## Appeal 34829

**Status:** Decision Rendered - Reconsideration of 34808

**Project Address:** 3440 SW Falcon St., Portland OR 97219

**LUR or Permit Application #:** Permit 25-027199 and 25-040811

submitted 5-19-25 (10)

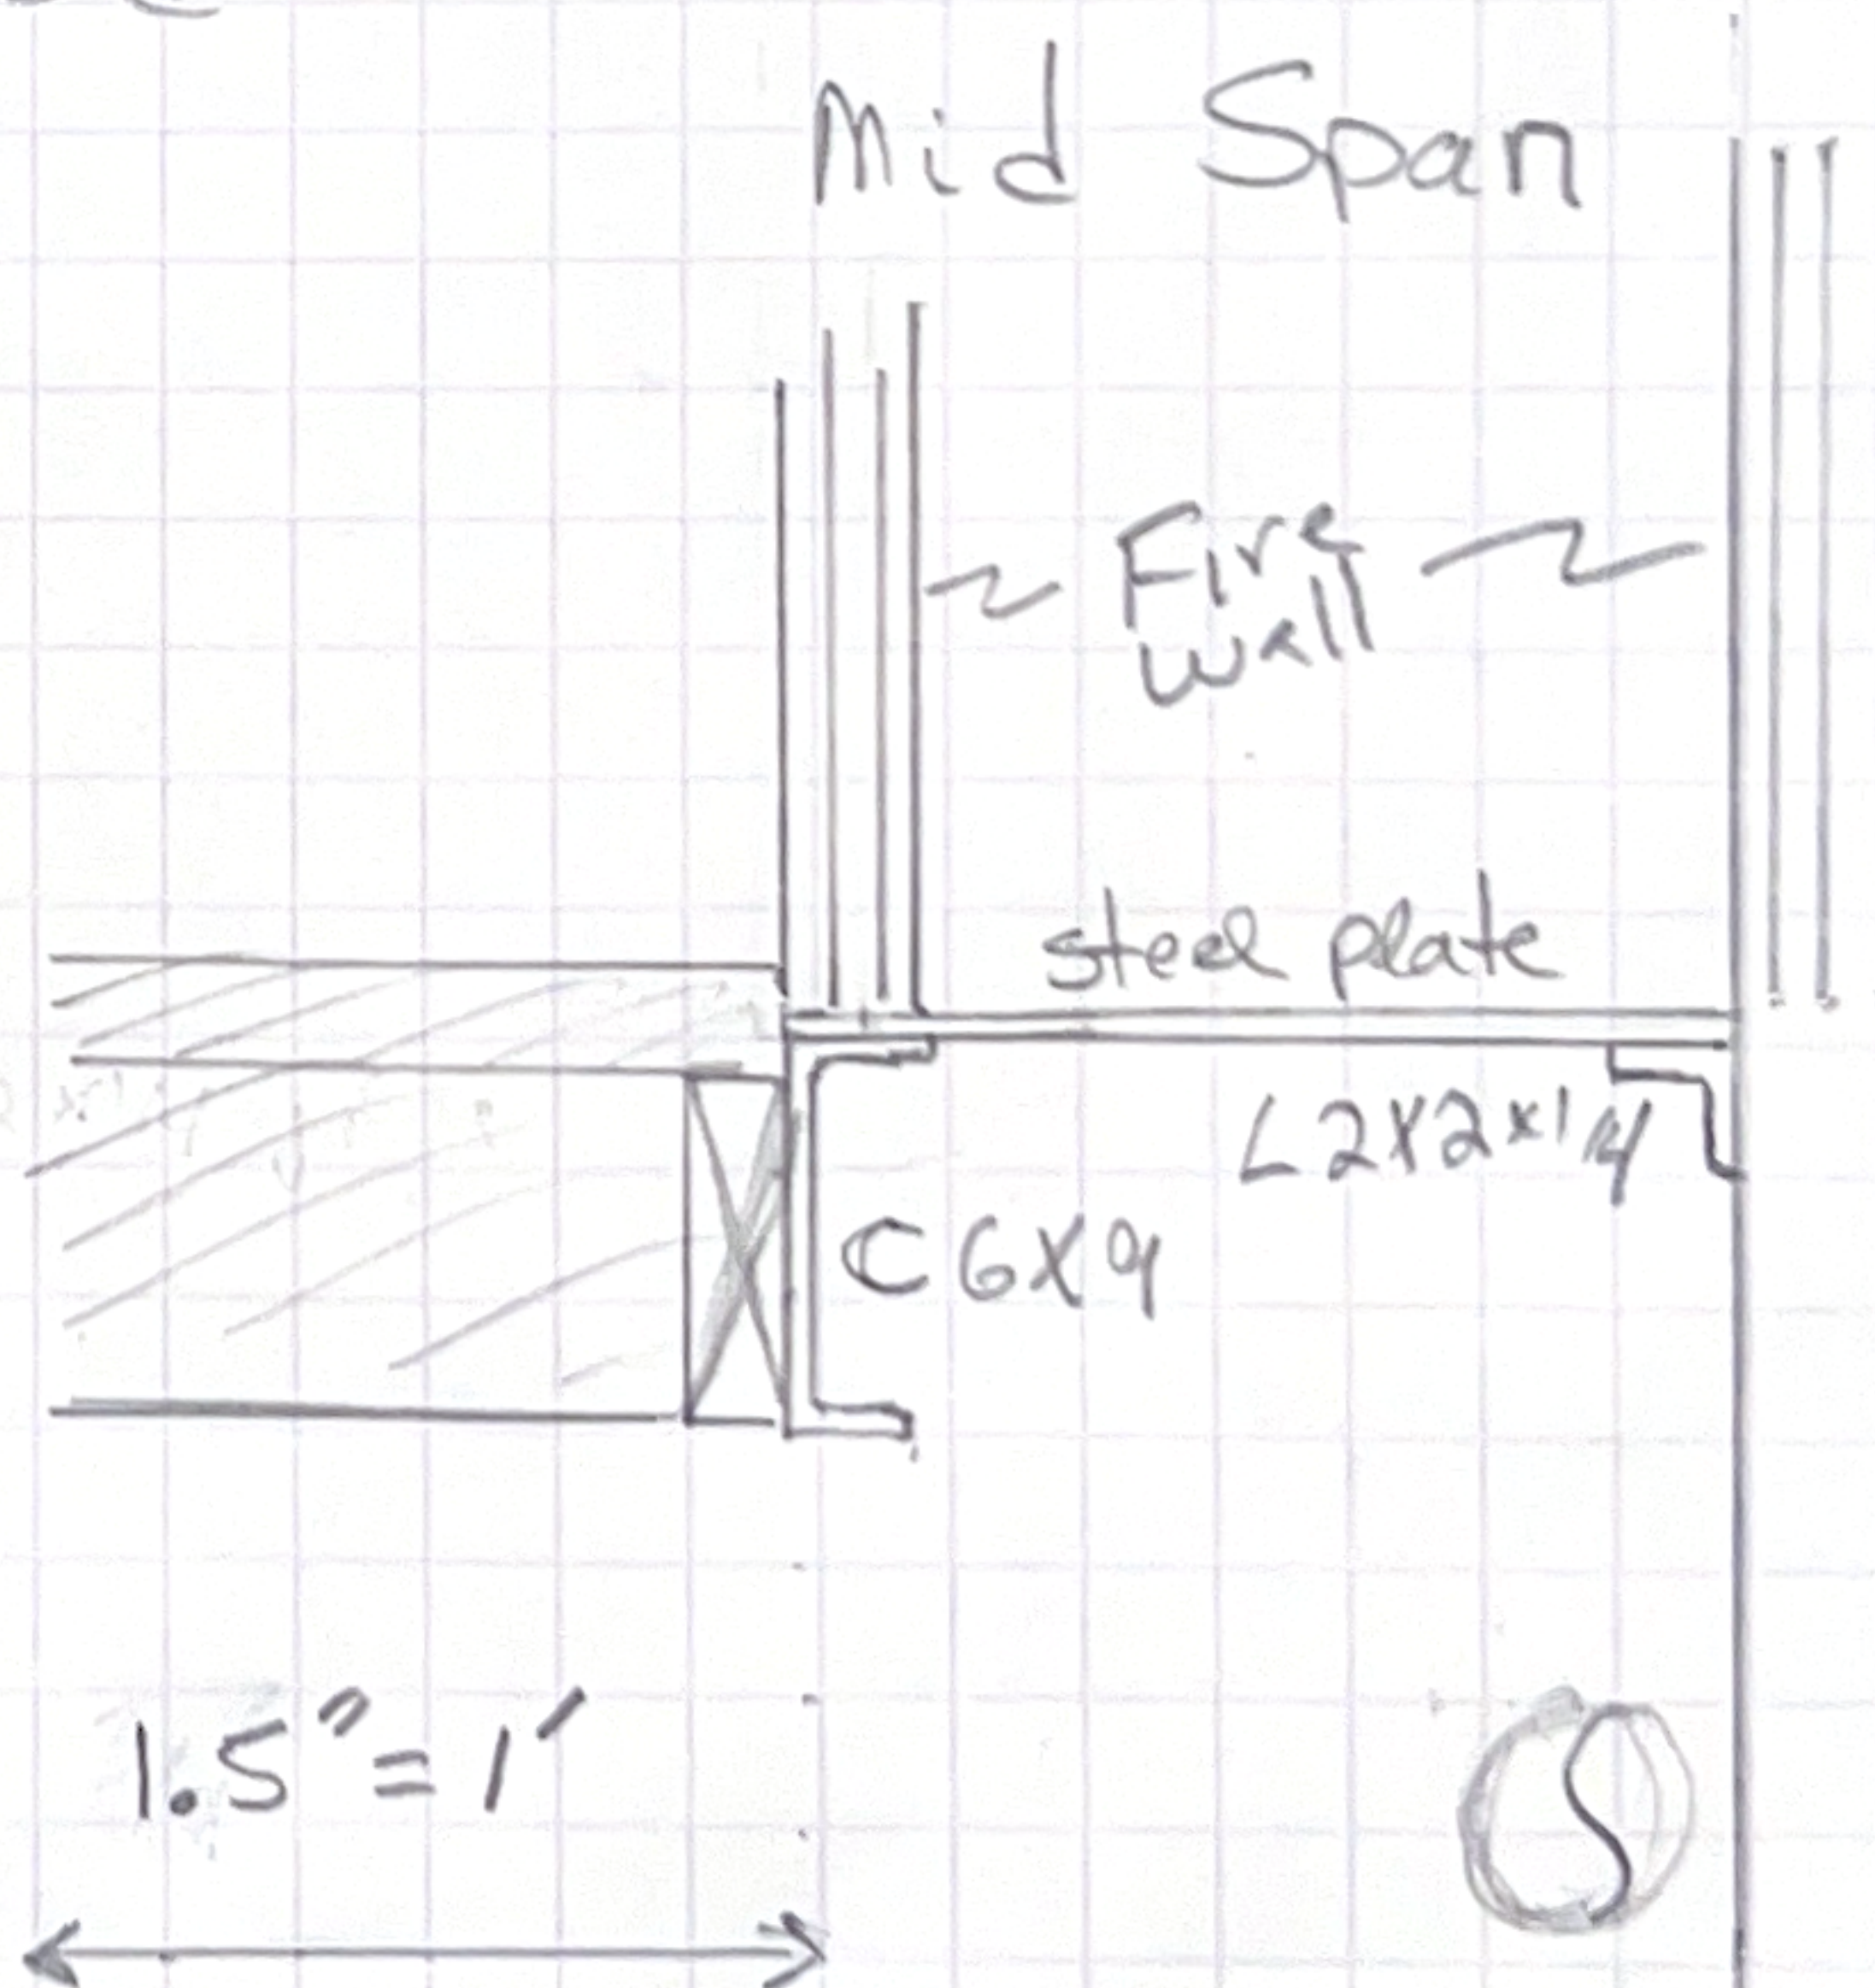
**"Allow an alternate path to meeting the requirement for 1-hour fire-resistance rated construction at an egress stairway: Denied. Proposal does not provide equivalent fire and life safety. Appellant may contact David Bartley (503-865-6529) with questions."**
